PROPOSED TECHNICAL SPECIFICATION CHANGES

ANO-1

Figure 3.11-1

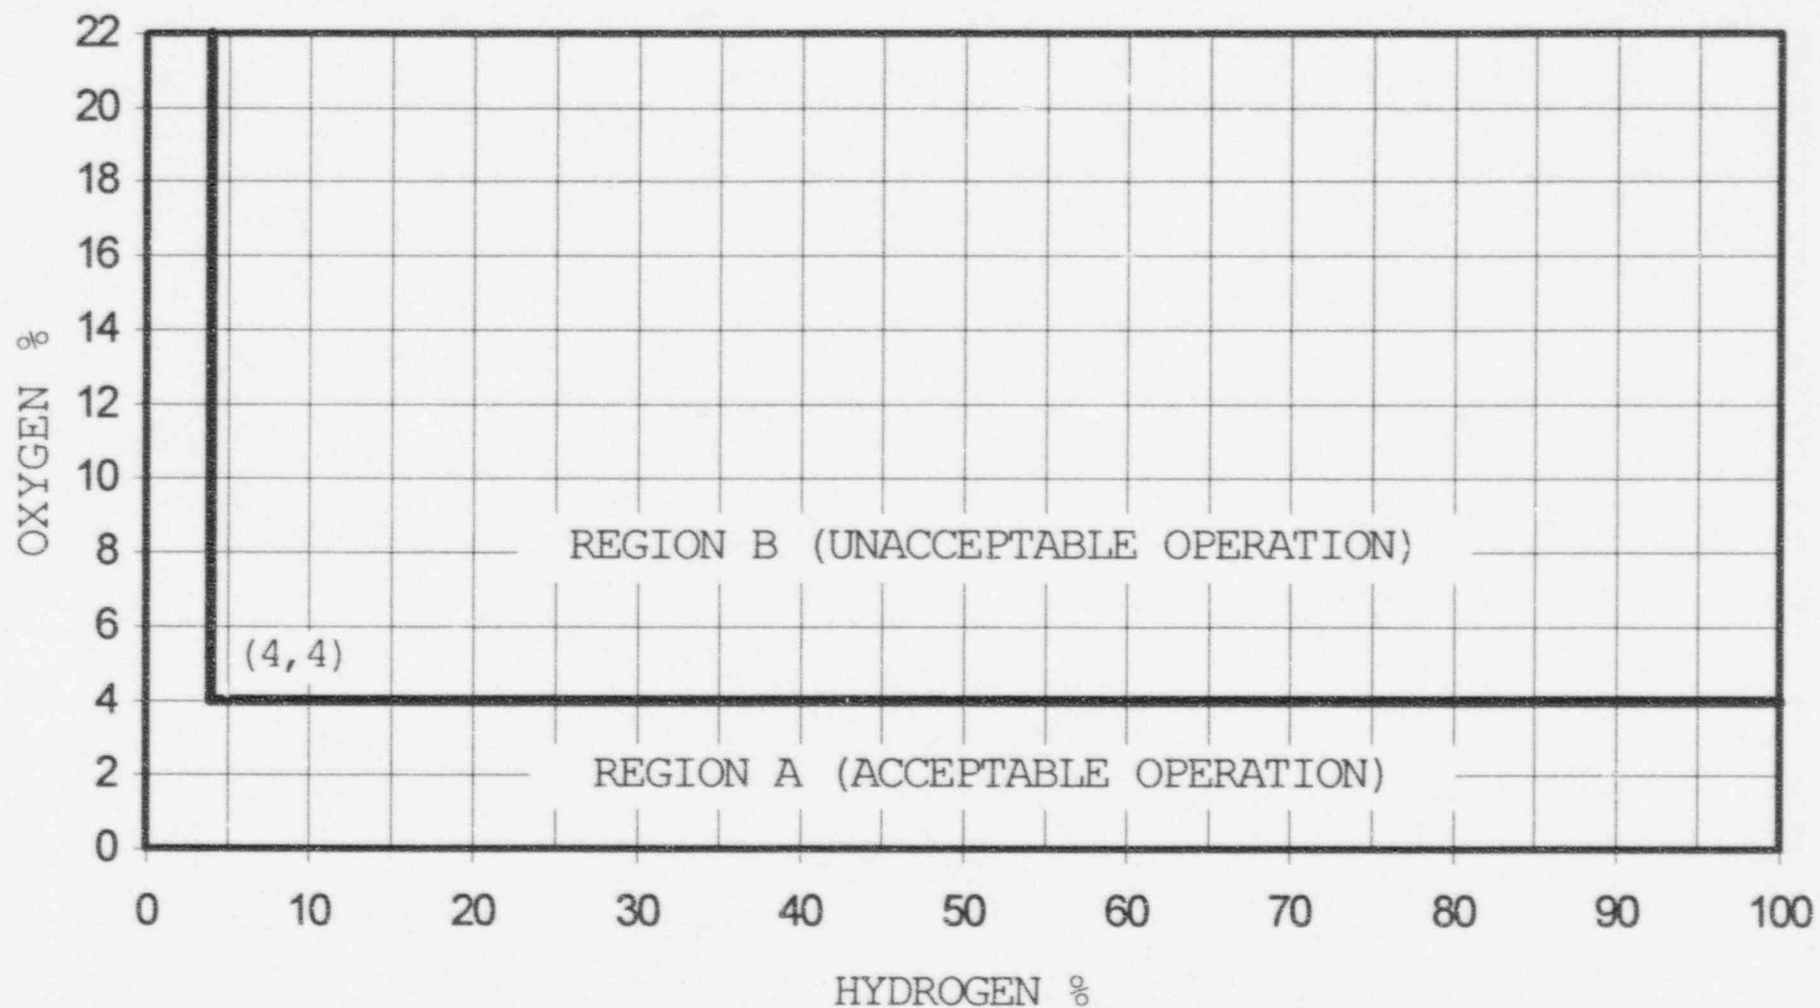
3.11.3 The concentration of the hydrogen/oxygen shall be limited in the waste gas storage tanks to Region "A" of Figure 3.11-1.

- a. When the concentration of hydrogen/oxygen in the waste gas storage tanks enters Region "B" of Figure 3.11-1, corrective action shall be taken to return the concentration values to Region "A" within 24 hours.
- b. The provisions of Specification 3.0.3 are not applicable.

Figure 3.11-1

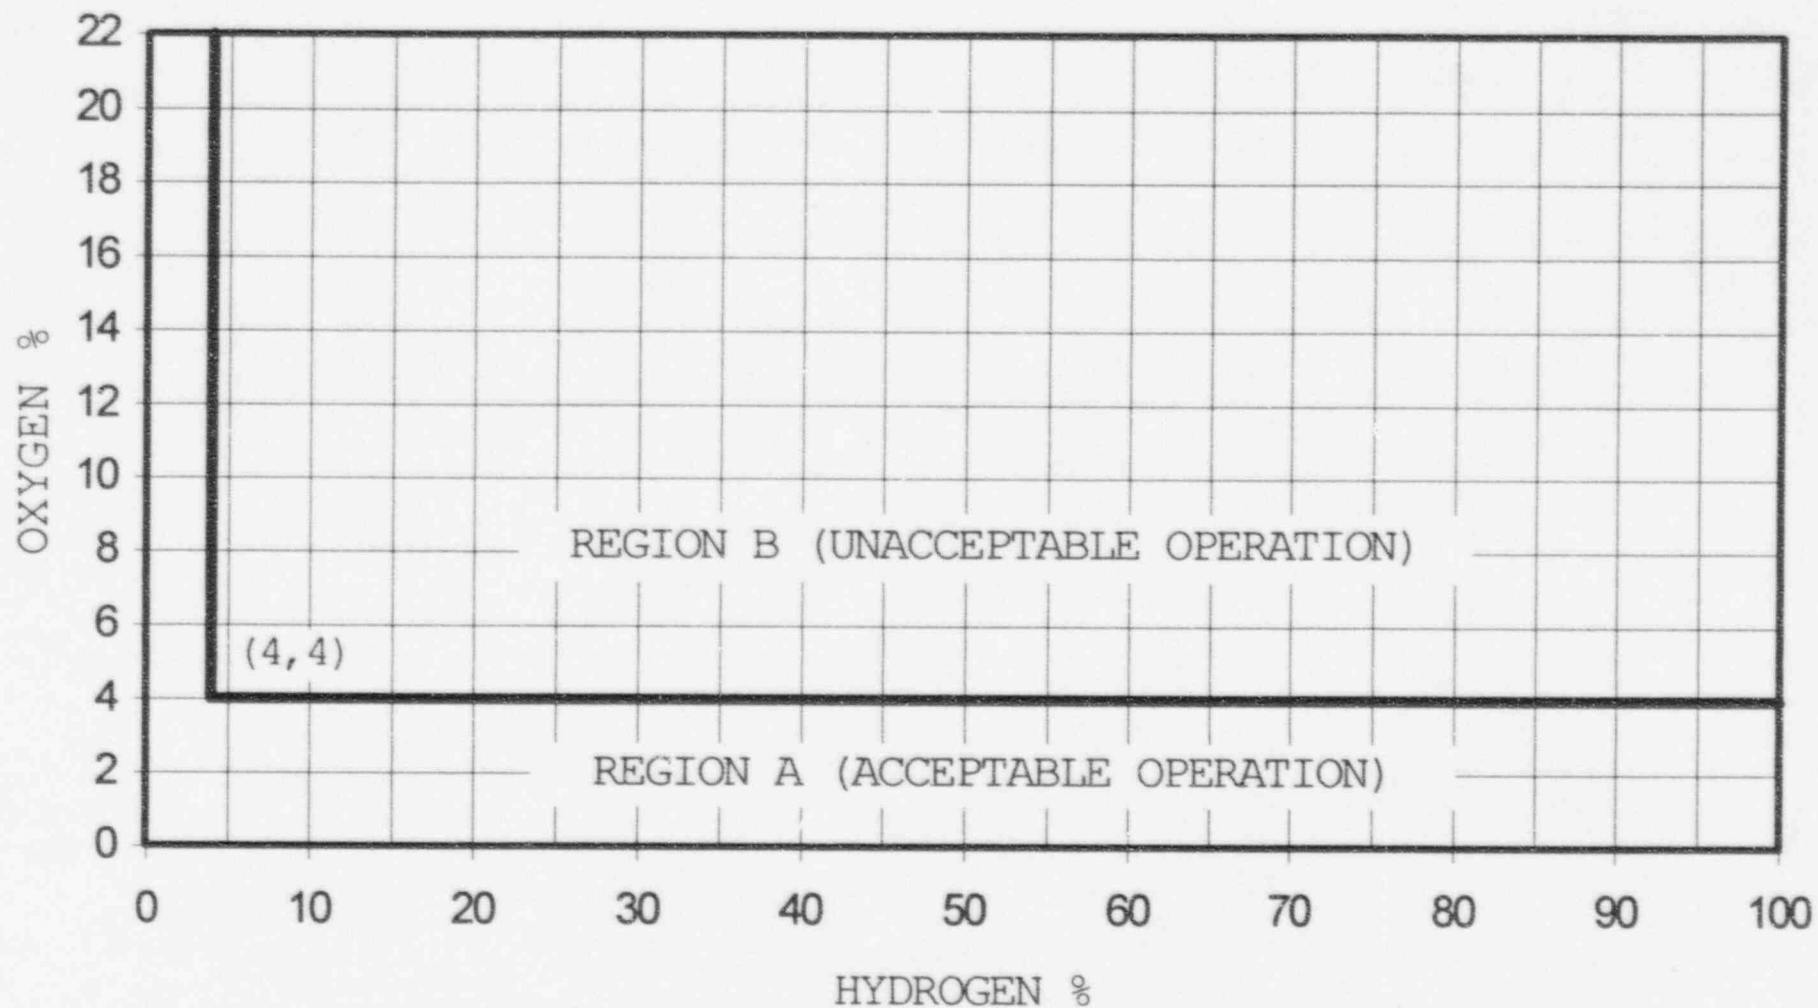
3.11.3 The concentration of the hydrogen/oxygen shall be limited in the waste gas storage tanks to Region "A" of Figure 3.11-1.

- a. When the concentration of hydrogen/oxygen in the waste gas storage tanks enters Region "B" of Figure 3.11.1, corrective action shall be taken to return the concentration values to Region "A" within 24 hours.
- b. The provisions of Specification 3.0.3 are not applicable.

Figure 3.11 - 1

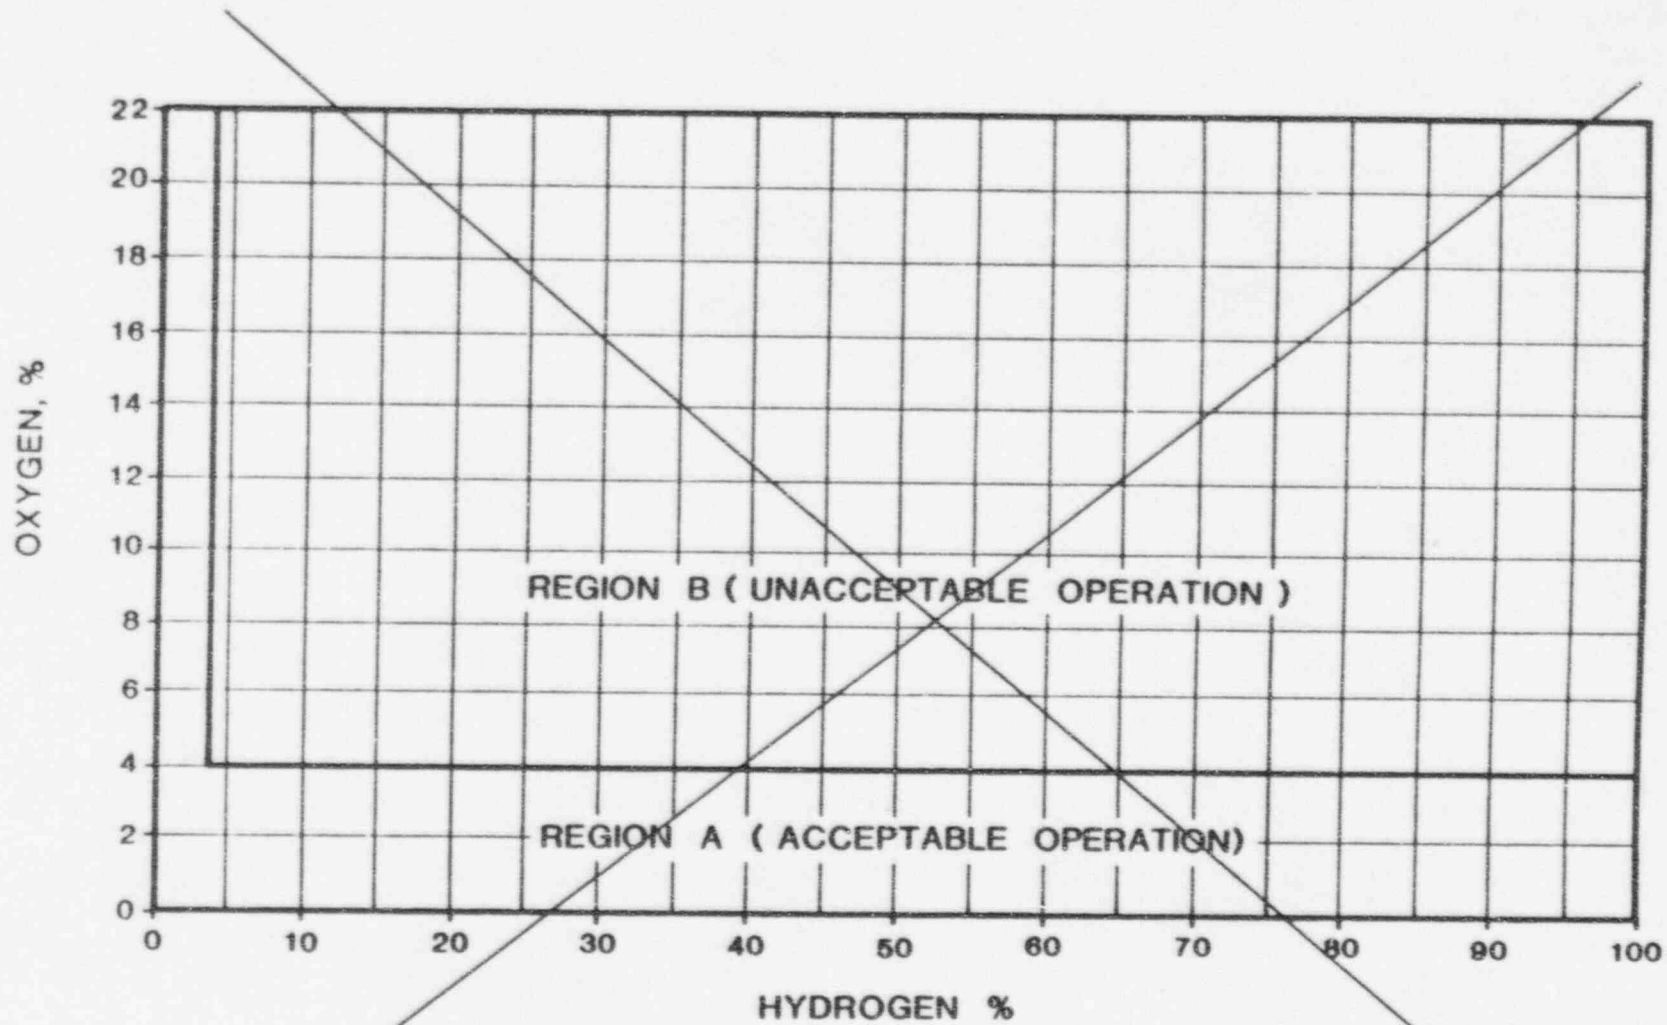
~~3.11.2.7 The concentration of the hydrogen/oxygen shall be limited in the waste gas storage tanks to Region "A" of Figure 3.11.1.~~

- ~~a. When the concentration of hydrogen/oxygen in the waste gas storage tanks enters Region "B" of Figure 3.11.1, corrective action shall be taken to return the concentration values to Region "A" within 24 hours.~~
- ~~b. The provisions of Specifications 3.0.3 are not applicable.~~

(This Specification moved to page 3/4 11-4 and this page will be deleted)

(This Specification moved to page 3/4 11-5 and this page will be deleted)

FIGURE 5.1-3

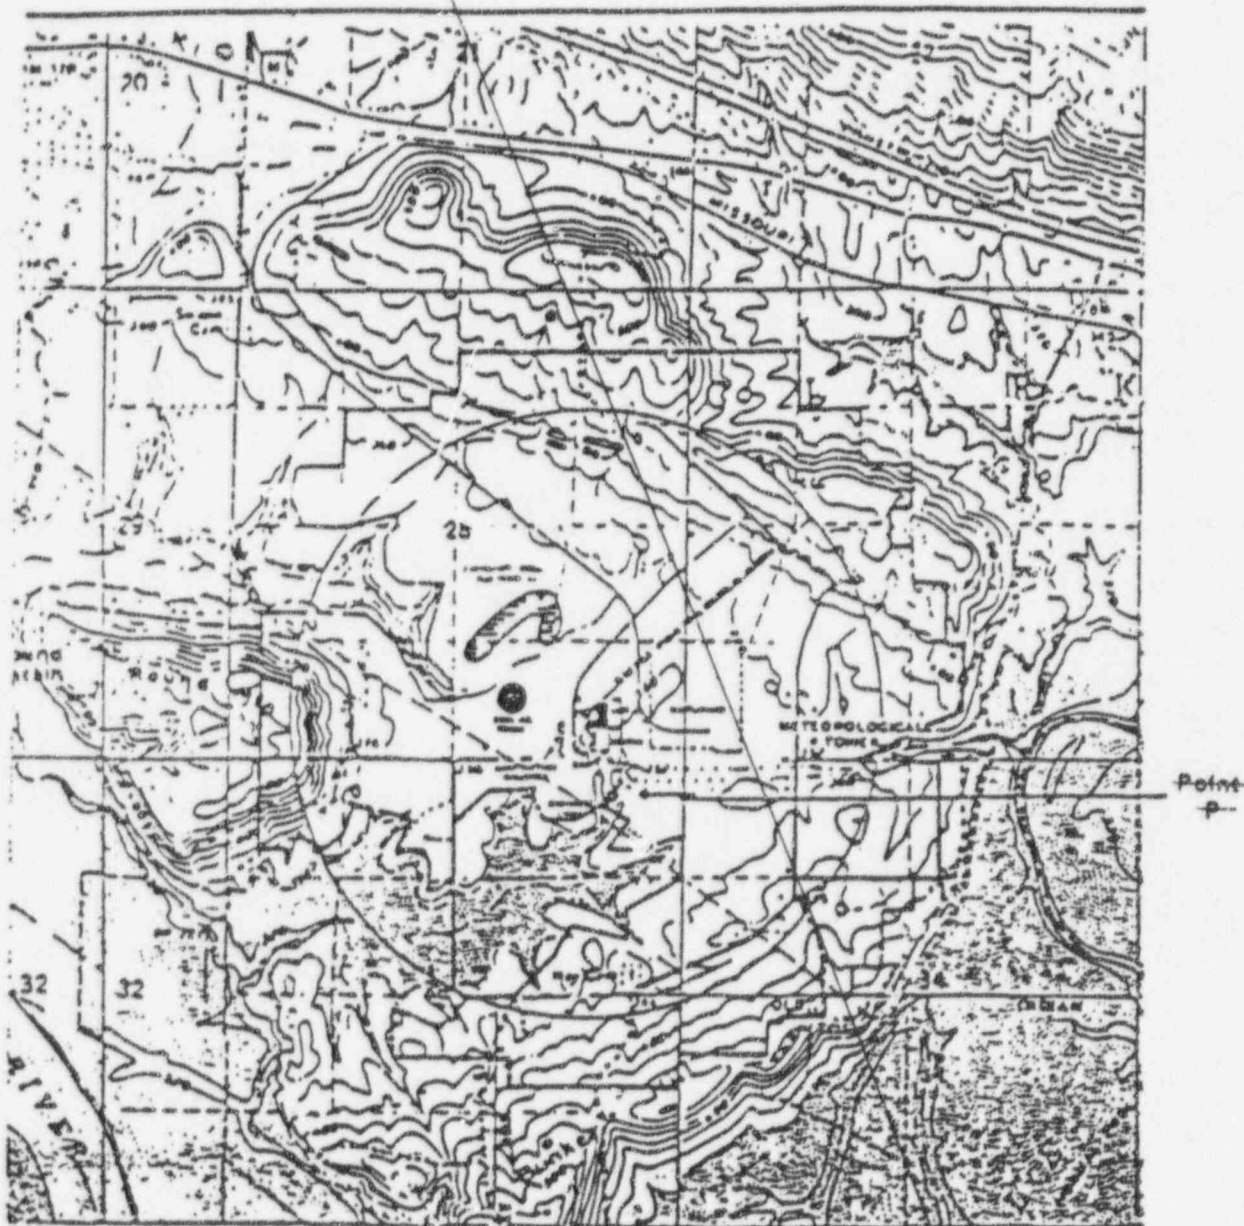
~~3.11.2.1 The dose rate due to radioactive materials released in gaseous effluents from the site to UNRESTRICTED AREAS (see Figure 5.1-3) shall be limited to the following:~~

~~3.11.2.2 The dose due to noble gases released in gaseous effluents from ANO-2 to UNRESTRICTED AREAS (see Figure 5.1-3) shall be:~~

DELETED

3.11.2.1 The dose rate due to radioactive materials released in gaseous effluents from the site to unrestricted areas (see Figure 4-2) shall be limited to the following:

3.11.2.2 The dose due to noble gases released in gaseous effluents from ANO-2 to unrestricted areas (See Figure 4-2) shall be:

FIGURE 4-2

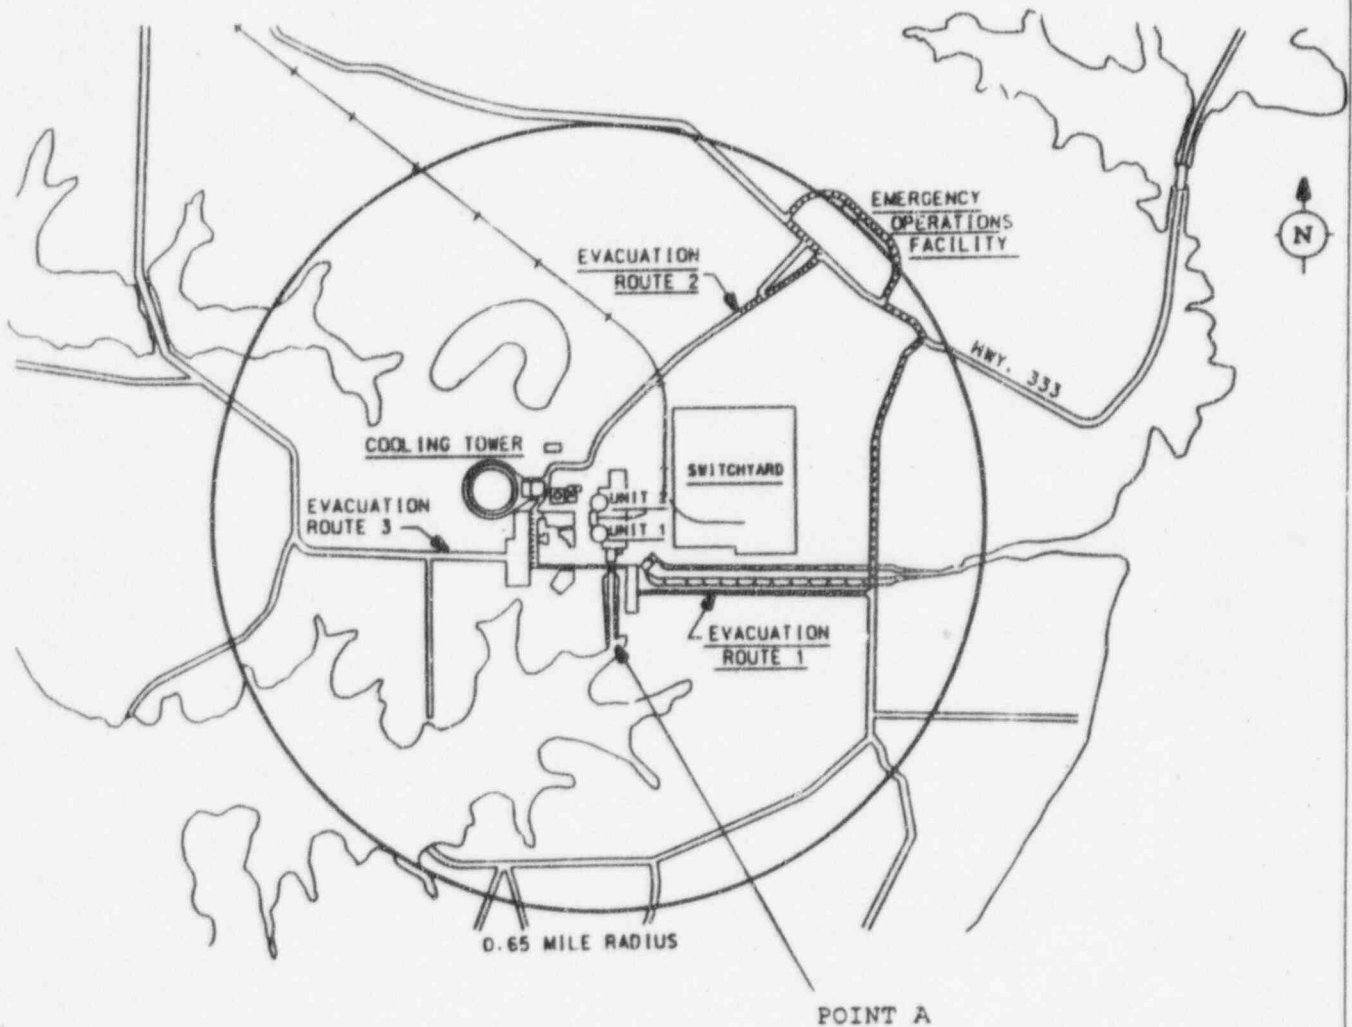
3.25.2.1 A. The dose rate in unrestricted areas (see Figure 4-2) due to radioactive materials released in gaseous effluents from the site shall be:

- 3.25.2.2 A. The dose due to noble gases released in gaseous effluents from ANO-1 to unrestricted areas (see Figure 4-2) shall be:
- 1) During any calendar quarter, less than or equal to 5 mrads for gamma radiation and less than or equal to 10 mrads for beta radiation, and
 - 2) During any calendar year, less than or equal to 10 mrads for gamma radiation and less than or equal to 20 mrads for beta radiation.
- B. With the calculated dose from radioactive noble gases in gaseous effluents exceeding any of the above limits, in lieu of any other report, prepare and submit a Special Report to the Commission within 30 days, pursuant to Appendix 1, Limitation 6.12.5.
